**PLANNING DIRECTOR'S SPECIAL PERMIT  
FOR SINGLE FAMILY RESIDENTIAL IN A PUD**

**FILE:** P00-016

**PROJECT NAME:** Northborough Village 1

Exhibit 1 - Site Plan/Setbacks

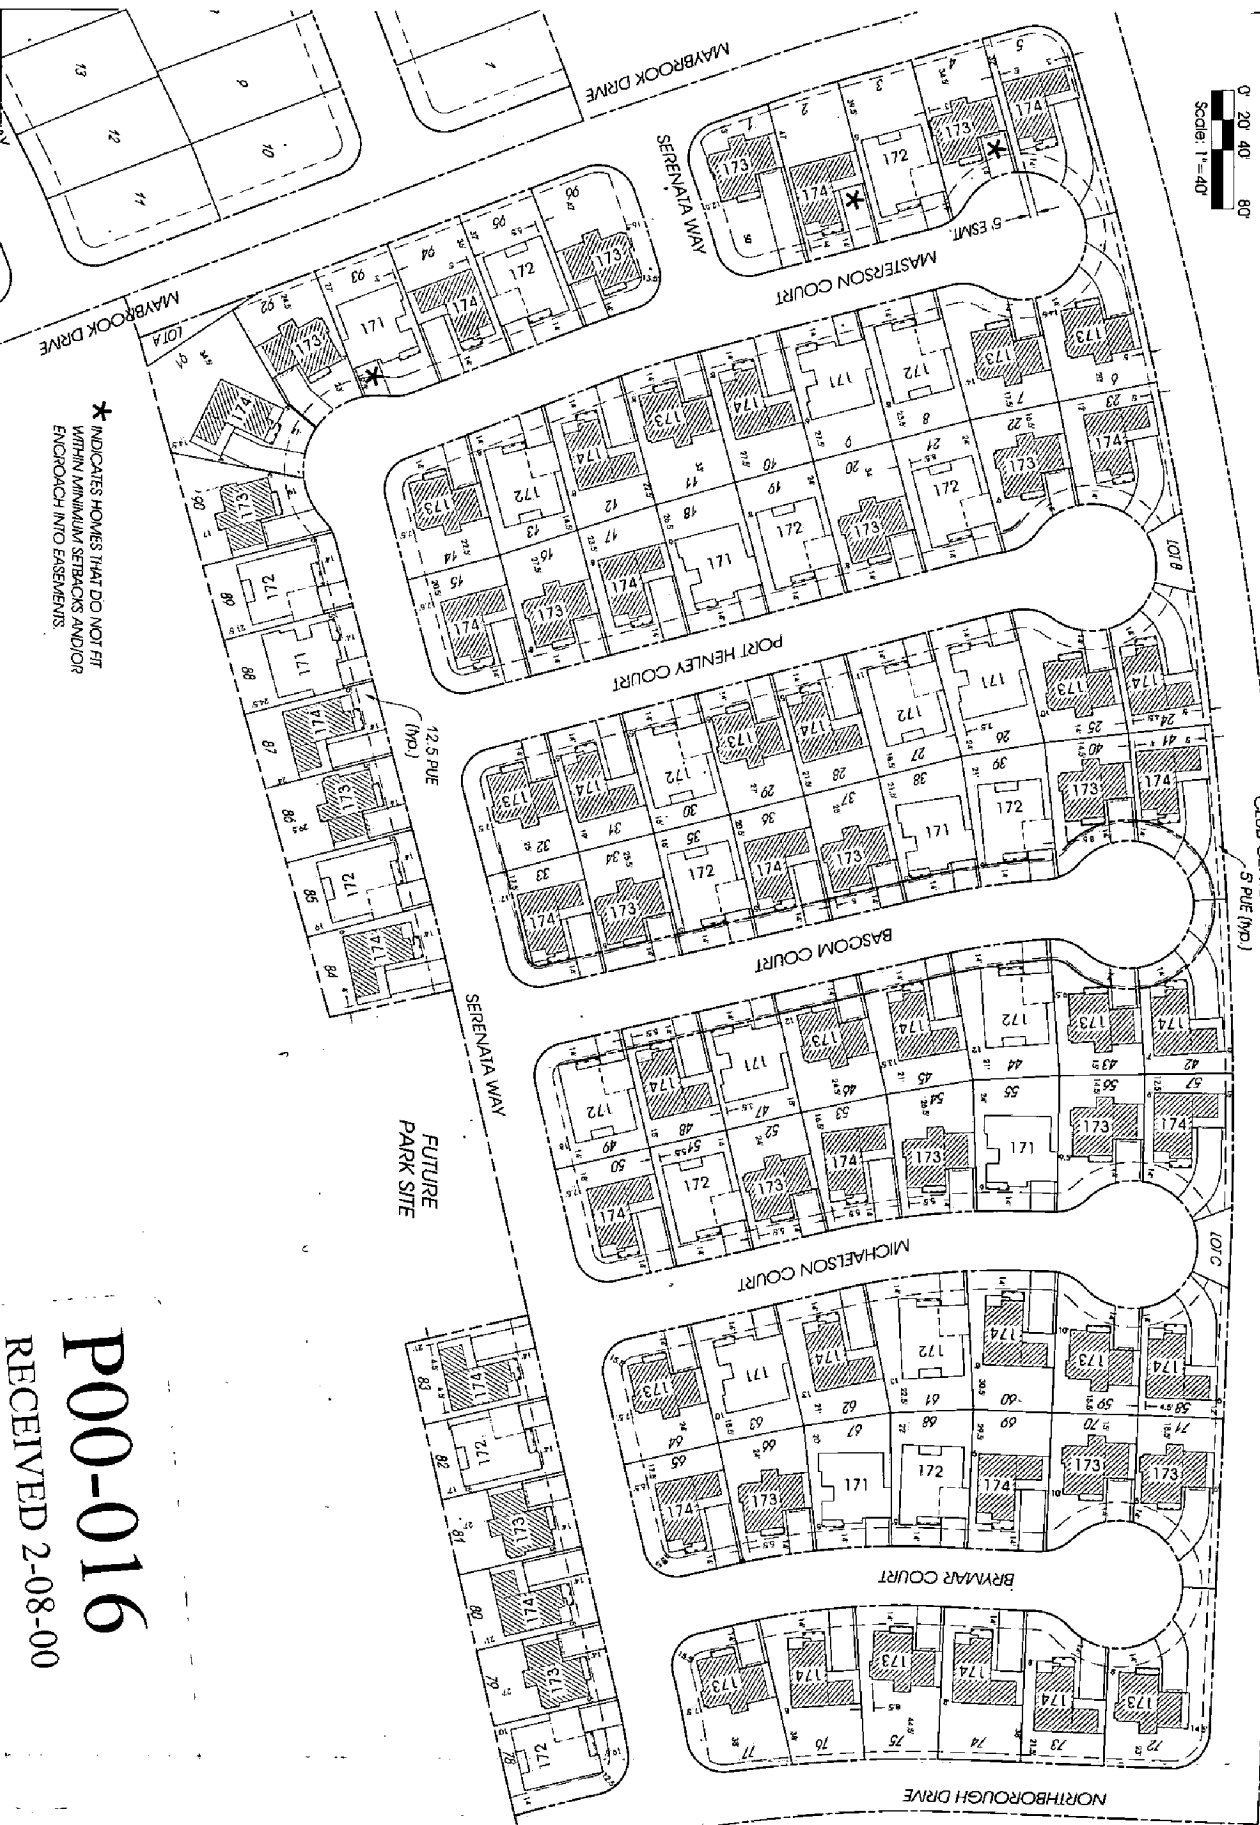
\* INDICATES HOMES THAT DO NOT FIT WITHIN MINIMUM SETBACKS AND/OR ENDOURCH INTO EASEMENTS

2. Prior to development of a model home complex, the applicant shall obtain a Zoning Administrator's Model Home Special Permit.
3. The plans with deficient setbacks as indicated in the site development plan shall be modified to meet setback requirements as per Northborough Planned Unit Development Guidelines.
